## Detailed Site Plan Ourisman of Bowie

## DSP-23026

STAFF REPORT

SUBJECT: Detailed Site Plan DSP-23026  
Type 2 Tree Conservation Plan TCP2-089-05-01  
Variance to Section 25-122(b)(1)(G)  
Ourisman of Bowie

Figure 2: Detailed Site Plan

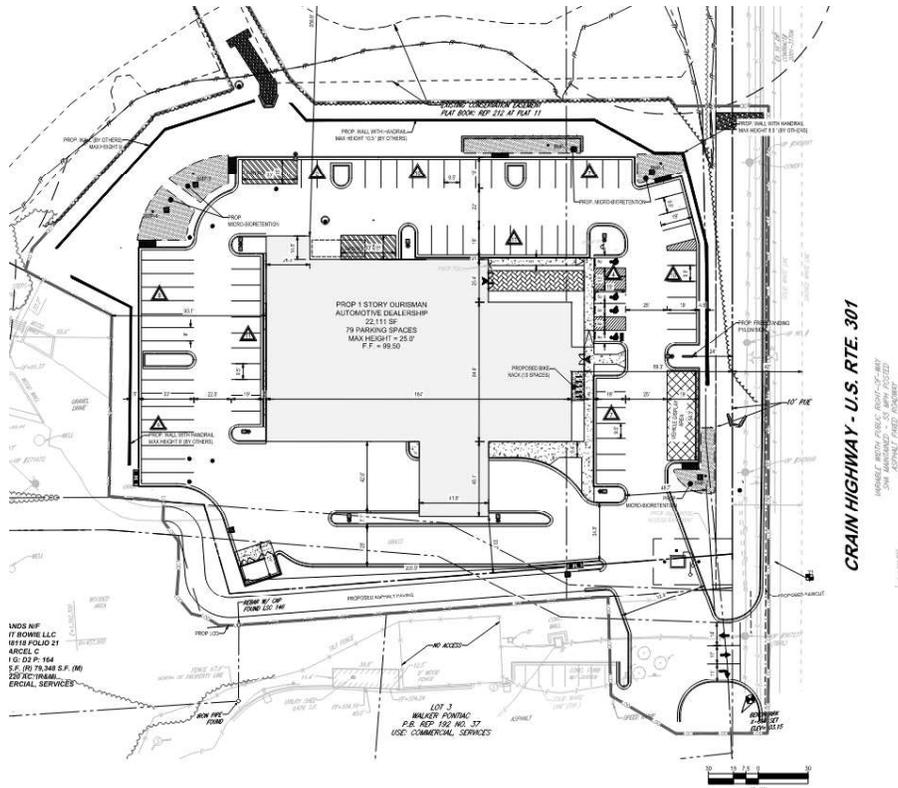
1. Prior to certificate approval of the detailed site plan, the following revisions shall be made, or information should be provided:
  - a. Revise General Note 6 to correct the proposed gross floor area.

- b. Revise the landscape plans to demonstrate conformance with Section 4.3(c)(2)(D) of the 2010 *Prince George's County Landscape Manual*, regarding minimum tree planting area requirements.

- f. Provide site details for the curb and gutter and tapering along US 301 (Robert Crain Highway) and identify these details on the site plan.
  - g. Revise landscape Schedule 4.7 for Bufferyard 1 to correctly identify the adjacent use.

- h. Show and label denial of access to US 301 (Robert Crain Highway) for Lot 1, except at the location of the shared vehicular access easement.
  - i. Add a note to the coversheet indicating that any off-site improvements to Lot 3 shall require proper permits and approvals per the Prince George's County Code.
